**FINAL**  
**ENVIRONMENTAL IMPACT REPORT**

**LION'S GATE RESERVE**

**Lead Agency: County of Santa Clara**

**File #4039-67-28-93**  
**SCH #94043016**

Figure  
**6**

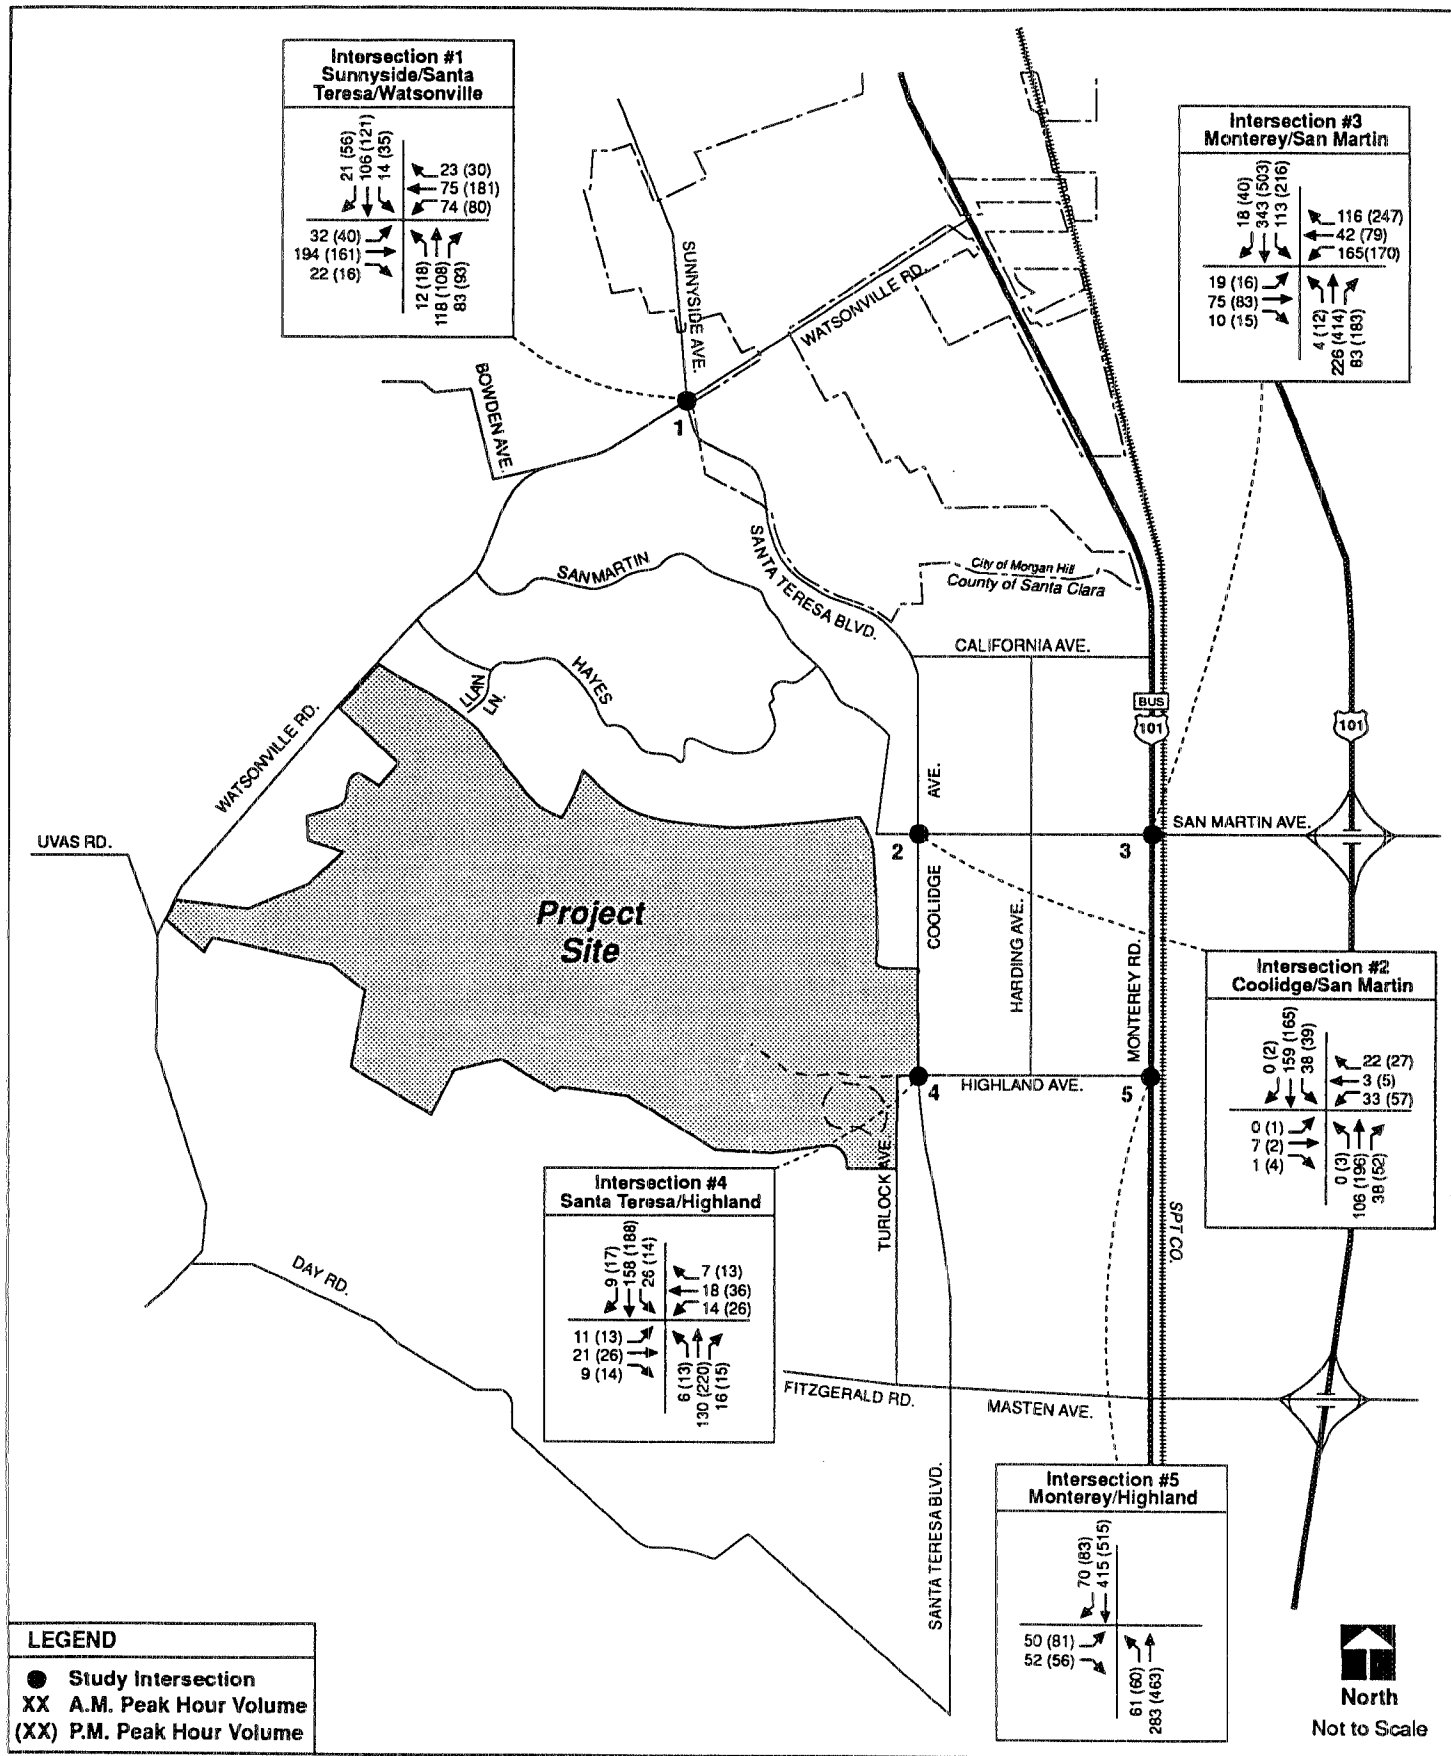
" Background Traffic-Existing Plus Approved Projects," last sentence refers to "a table of these approved projects and a figure...in Appendix G of this EIR." There is no such table in Appendix G, the Historical and Architectural Evaluation section. Could this be a reference to the "missing" Figure 3 in Appendix H?

- a. Figure 1: existing transit routes in vicinity of proposed project
- b. Figure 3: locations of approved projects near study area
- c. Figure 4: project turning movement volumes
- d. Figure 6: trip distribution assumptions
- e. Figure 7: projected study intersection turning movements for existing plus approved plus project
- f. Figure 8: forecasted turning movement volumes

Is it possible that some of the figures in Volume I of the DEIR, i.e., figures 18, 19, or 20, should have been the figures provided in items b, c, d, e above? Please clarify.

3. The reference to Appendix G should have read "Appendix H." The table listing the approved projects is identified as Table II of the traffic report in Appendix H. The EIR has been revised to include this corrected information. (See Section *V. TEXT AMENDMENTS*.)
4. Comment acknowledged. All but one of the figures prepared by TJKM for Appendix H were inadvertently omitted from DEIR Volume III. Several of these missing figures appear in Volume I of the DEIR as follows: the missing Figure 1 in Appendix H is the same as Figure 17 in the DEIR; Figure 2 is the same as Figure 18; Figure 4 is the same as Figure 19; Figure 6 is the same as Figure 20; and Figure 7 is the same as Figure 21 in the DEIR. Figures 3 and 8 are missing altogether. The EIR has been amended to include the figures missing from Appendix H. (See Section *V. TEXT AMENDMENTS*.)
